Superfund Program

Proposed Plan DRAFT - July 2015 Allied Paper Landfill Allied Paper/Portage Creek/Kalamazoo River Superfund Site – Operable Unit 1

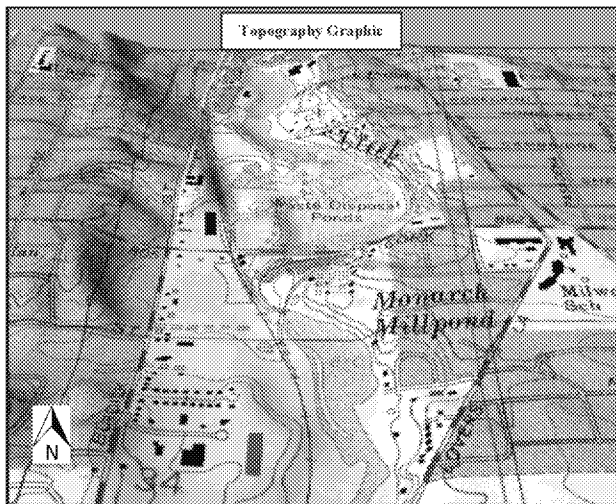
Commented [RLF2]: The figure below needs a north arrow...
